**ADDISON AIRPORT
BUILDING REPORT**

Facility Name: 4551 Glenn Curtiss Drive

Date: May 3, 2017

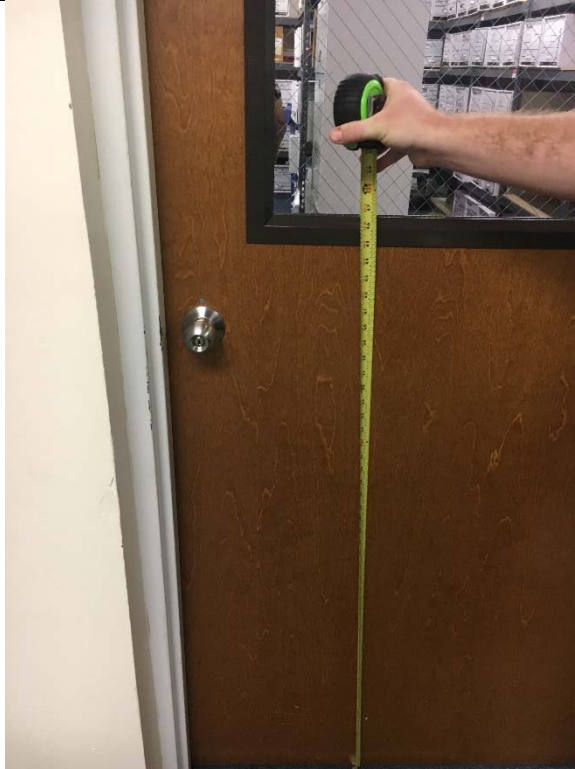
Violation 1 - There are no accessible parking provided at this building.

Violation 2 - The ground around the entrance is cracked and uneven with gaps up to 1-1/2" in some places.

Violation 3 - There is not a 5' level maneuvering clearance on the pull side of the entrance door. The pavement drops off 1/2".

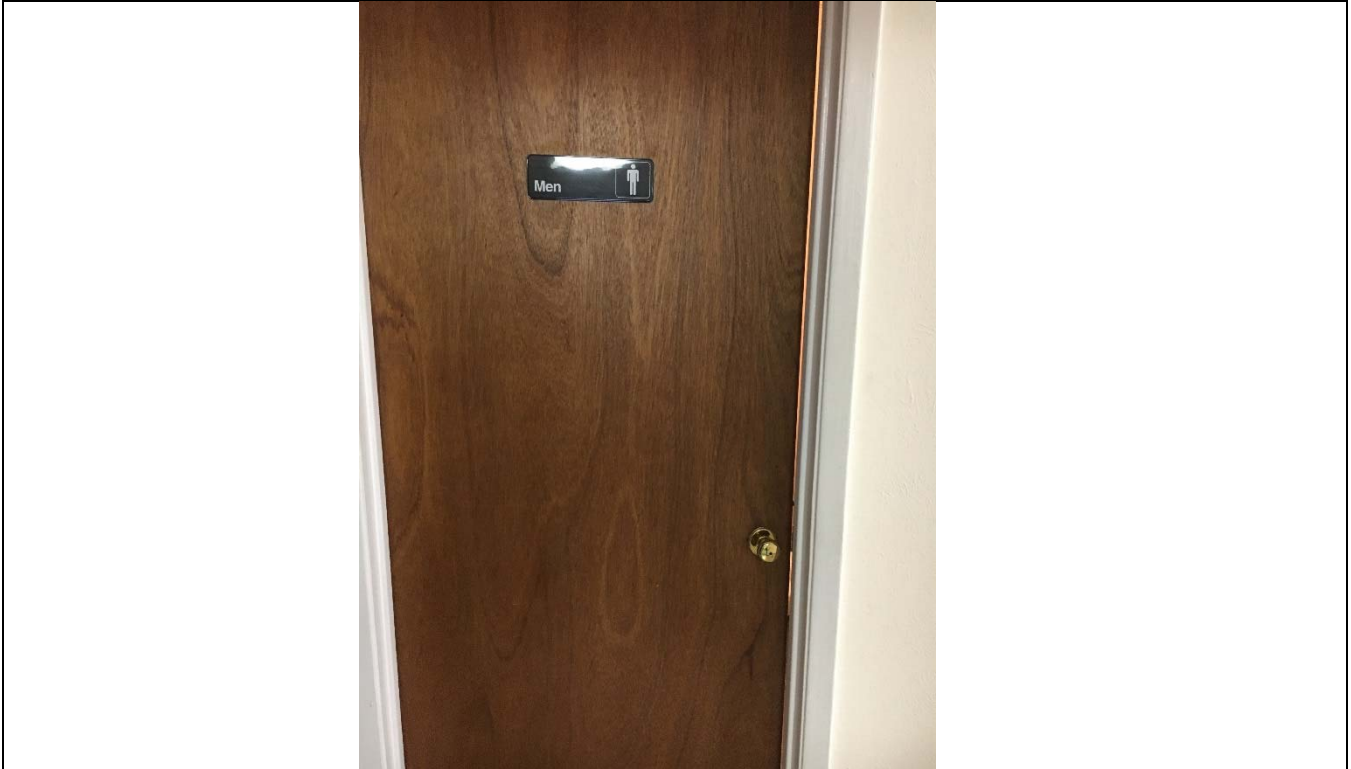
Violation 4 - There are 8 interior doors with door hardware that requires grasping and twisting to operate.

Violation 5 - The vision panel on the door leading into the storage room is at 46-3/8".

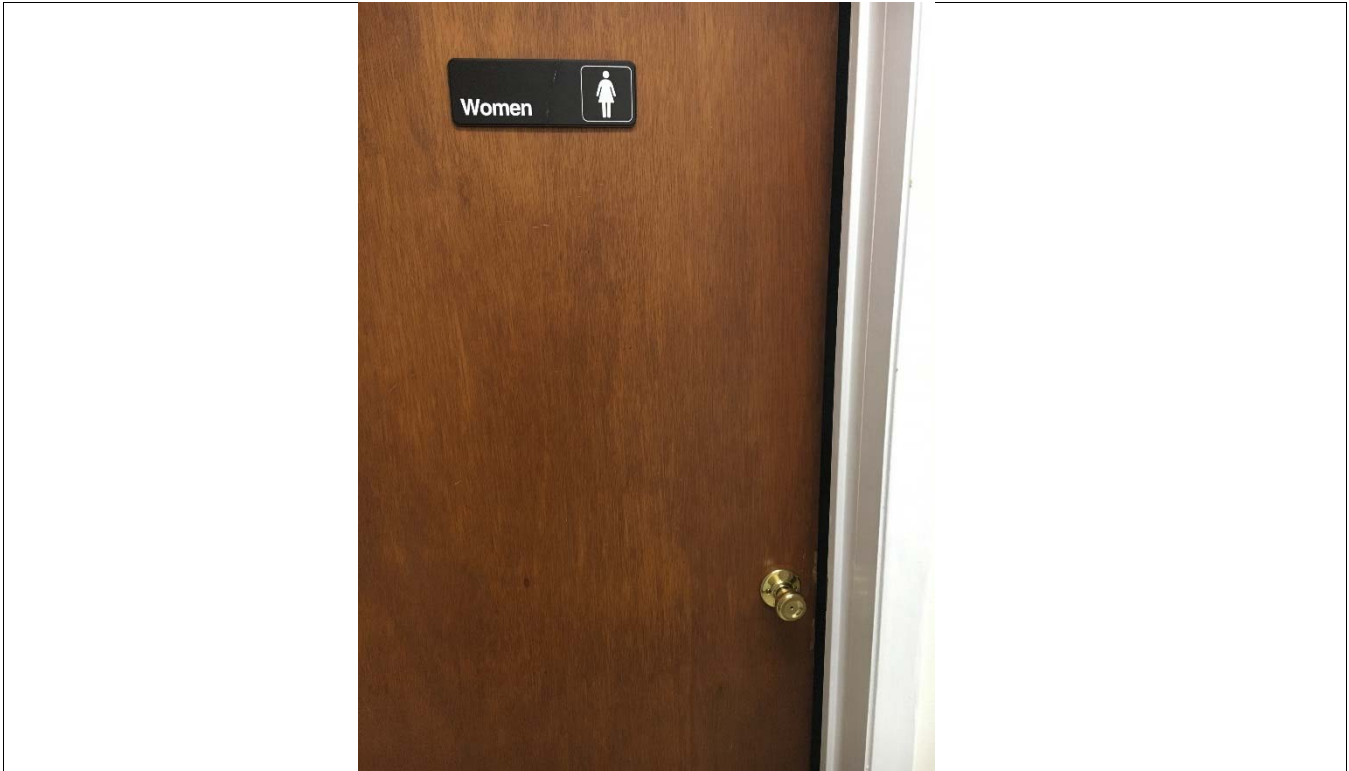
Violation 6 - The storage room in the warehouse has a 1-3/16" step to enter.

Violation 7 - The Men's restroom signage is mounted on the door.

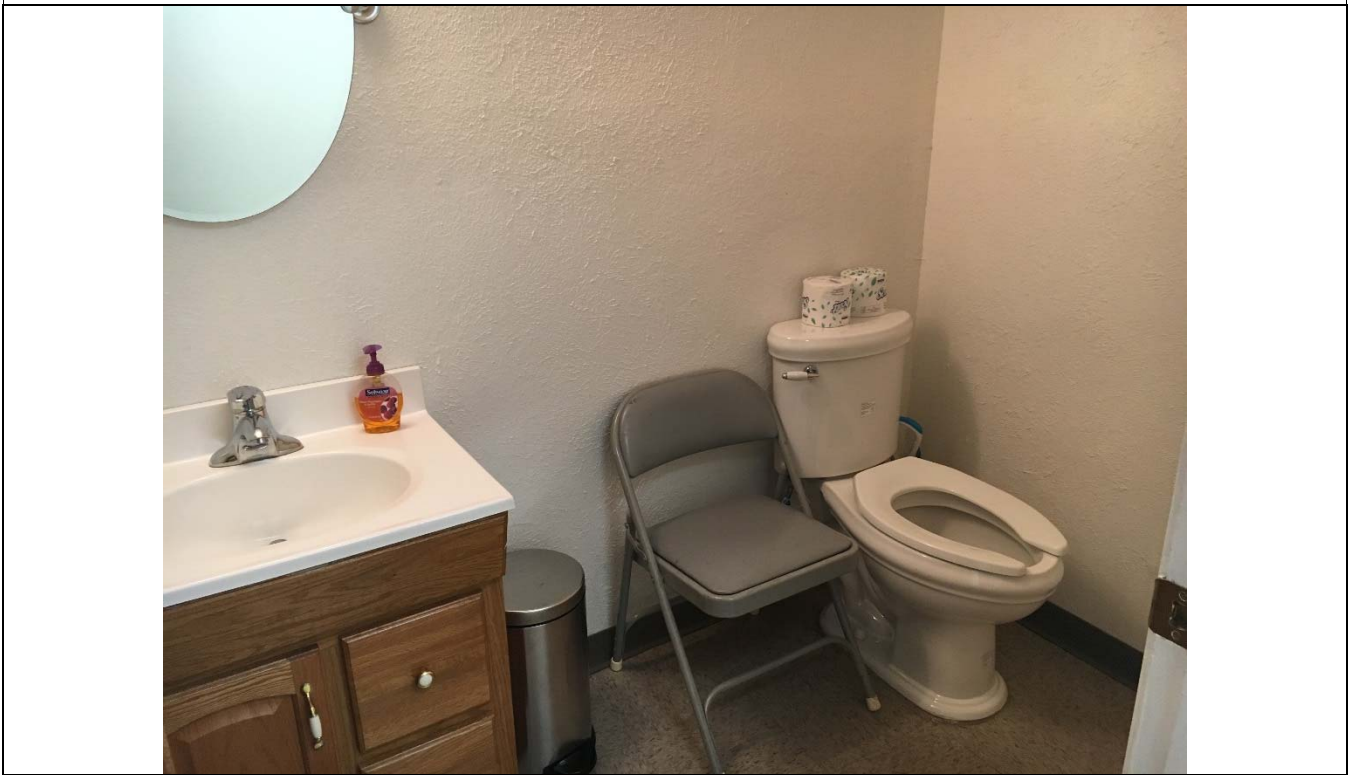
Violation 8 - The Men's restroom is too small and does not have the required turning radius provided.

Violation 9 - The Women's restroom signage is mounted on the door.
